Delegated Action of the Executive Director

PROJECT Gate Redesign Marine Barracks Washington Annex 8th and I Streets, SE Washington, DC	NCPC FILE NUMBER 7871
	NCPC MAP FILE NUMBER 41.00(38.00)44703
SUBMITTED BY United States Department of Defense Department of the Navy	ACTION TAKEN Approve as requested
	REVIEW AUTHORITY Approval Per 40 U.S.C. § 8722(b)(1) and (d)

Figure 1: Elevation of proposed MBW Annex Gate Project

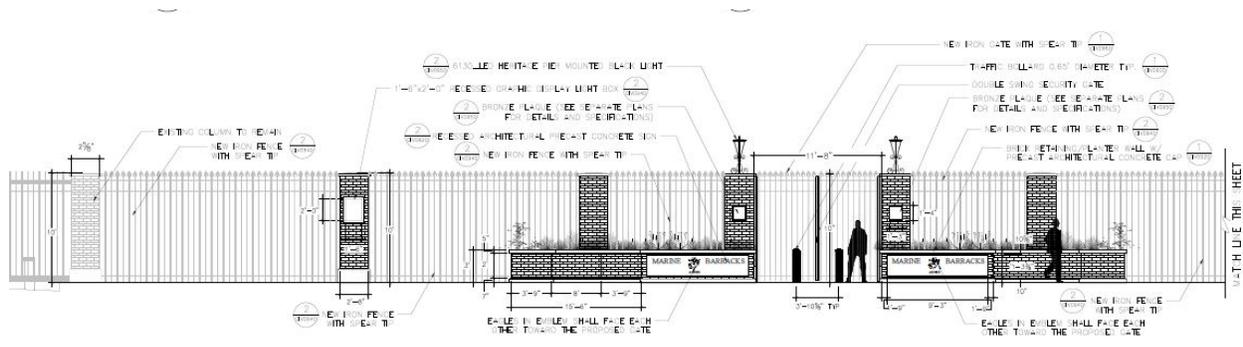
The current fence along 7th Street, SE, is a steel picket fence, 10 feet tall, constructed in 8' panels attached to square steel tubes that are set in concrete footings. The new fence will have the same type of construction, will also be 10 feet tall and attached to square steel tubes set in concrete footings. However, the panel widths will change to 6 foot, 8 inches. Additions to the re-designed fence line include seven new brick pillars to which the fence panels will be attached. Six of the brick pillars (paralleling 7th Street, SE) will be approximately 2 feet, 8 inches wide and 10 feet tall. The northern most pillar will be 2 feet, 8 inches to match the existing southern most pillar, which remains in place. The outer pillars will feature display cases which can accommodate a poster size of 30 inches wide by 42 inches tall. The proposed new gate design incorporates new brick columns that will display on-going and upcoming performances held at the auditorium. The pillars flanking the center gate will feature bronze placards with the Eagle, Globe, and Anchor (EGA) emblems, which be proportionate to the arch width. The Navy has responded to the Commission's recommendation and has removed the proposed concrete arch over the main

walkway which has helped to simplify the design. The Navy is now proposing lights on top of the pillars flanking the main pedestrian walk and staff is supportive of this change.
